**Northbrook
Arrowtown
Southern
Boundary**

Waterfall Park Developments Ltd – Northbrook Arrowtown, Environmental Management Plan

NORTHBROOK - ARROWTOWN
SEDIMENT & EROSION CONTROL PLAN

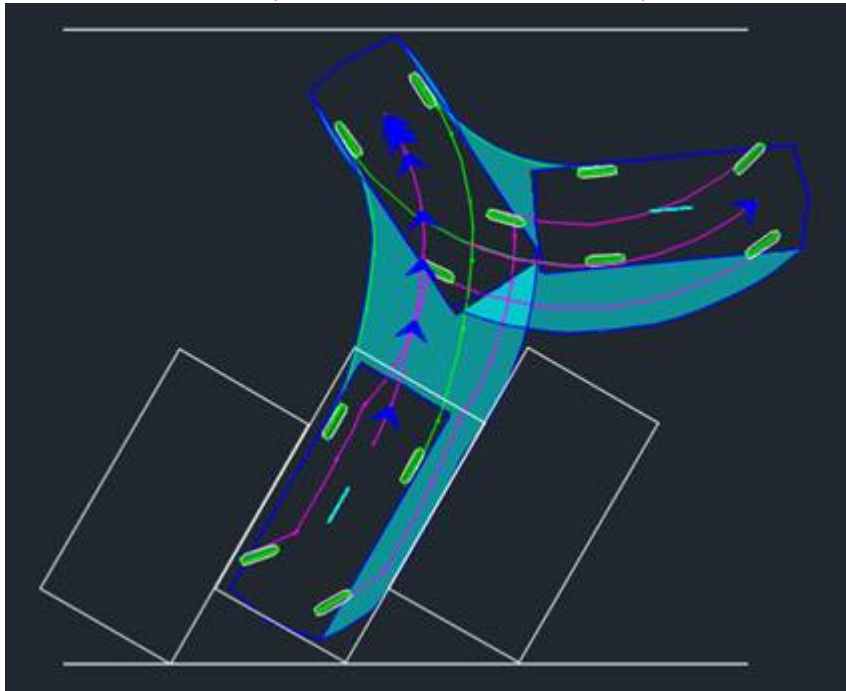
- Parallel parks and set down areas fronting Building A to be updated to include entry and exit tappers. For obvious reasons parallel parks and set down within age care facilities require entry/exit tappers.
- The engineering drawings have been updated (Sheet 301) to provide tapers to the Building A parallel parking spaces (loading and accessible).
